Product Change Notice

(PCN Tracking Number: EE-QR-211014-01)

Customer:	ALL Customers
Renesas Product Type:	USB3.0 Host/Hubb controller devices UPD720201K8-xxx-BAC-A, UPD720202K8-xxx-BAA-A, UPD720210K8-BAF-A
Description of Change:	Introduction of additional assembly and test sites: Assembly: PTI/Greatek (Powertech Technology, Group Greatek Electronics) Test: Sigurd-UTC (Sigurd UTC Corporation) Booking Part Numbers remain unchanged!
Reason for Change:	Increase of production capacity
Identification:	Identifiable via date code and package marking
Schedules:	Sample delivery: b/o Feb. 2022 Qualification report: b/o Mar. 2022 Requested approval e/o Mar. 2022 Change Implementation Apr. 2022
Anticipated Impact:	Form & Function: None Fit: Slight dimension difference in exposed-PAD size of UPD720210K8. Renesas judges the impact on customer's implementation is minor. Quality & Reliability: None
Doc. No.:	EEQC-PCN-CR-21-2058
Internal Reference:	APTE4-BB-21-0006

Table 2-1 UPD720201K8 IC Tray specification
ASH-SH(P/N JT5080801-01 REV.B)

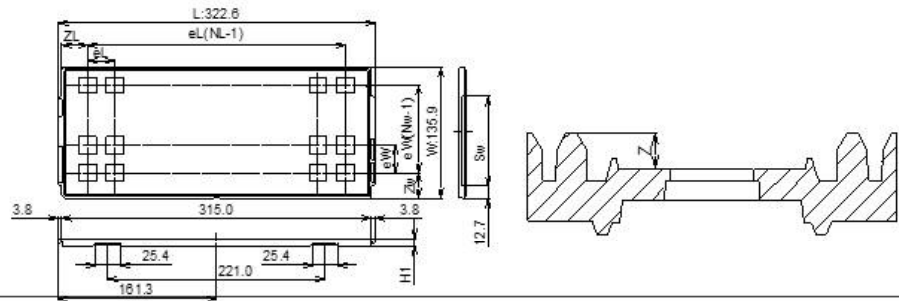
Position dimension of cells	Z	1.8
	Zw	10.35
	ZL	10.00
	eW	12.80
	eL	11.80
	Sw	92.1
Thickness (mm)	H1	7.62
Number of cells	Nw	10
	NL	26
Maximum storage No. IC/Tray		260
Material		PPE
Heat resistant temperature		150°C MAX
Surface resistance		$\geq 1.0 \times 10^9 \Omega$ & $< 1.0 \times 10^{12} \Omega$ ohm/sq

Position dimension of cells	Z	1.5
	Zw	10.75
	ZL	11.90
	eW	10.40
	eL	10.40
	Sw	92.1
Thickness (mm)	H1	7.62
Number of cells	Nw	12
	NL	29
Maximum storage No. IC/Tray		348
Material		PPE
Heat resistant temperature		150°C MAX
Surface resistance		$1 \times 10^9 \sim 1 \times 10^{12} \Omega$ OHM/SQ

Table 2-2 UPD720202K8 IC Tray specification
ASH-SH(P/N JT50070701-01 REV.B)

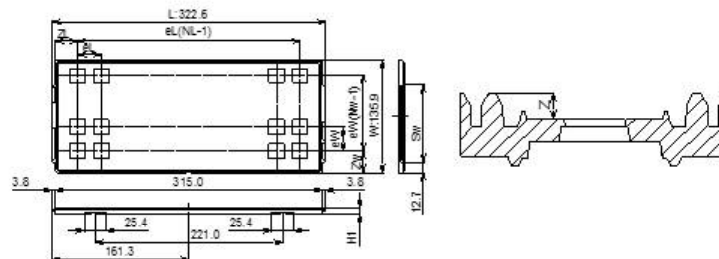
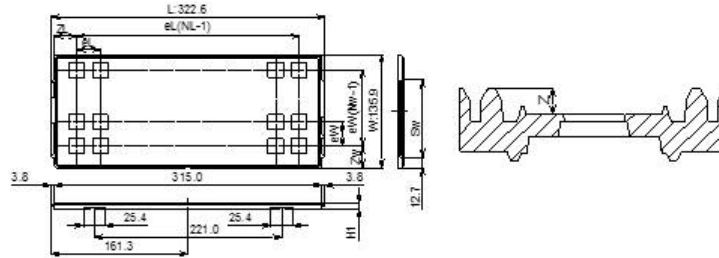
Position dimension of cells	Z	1.8
	Zw	10.35
	ZL	10.00
	eW	12.80
	eL	11.80
	Sw	92.1
Thickness (mm)	H1	7.62
Number of cells	Nw	10
	NL	26
Maximum storage No. IC/Tray		260
Material		PPE
Heat resistant temperature		150°C MAX
Surface resistance		$\geq 1.0 \times 10^9 \Omega$ & $< 1.0 \times 10^{12} \Omega$ ohm/sq

Position dimension of cells	Z	1.4
	Zw	11.55
	ZL	11.80
	eW	9.40
	eL	9.40
	Sw	92.1
Thickness (mm)	H1	7.62
Number of cells	Nw	13
	NL	32
Maximum storage No. IC/Tray		416
Material		PPE
Heat resistant temperature		150°C MAX
Surface resistance		$1 \times 10^9 \sim 9 \times 10^9 \Omega$ OHM/SQ
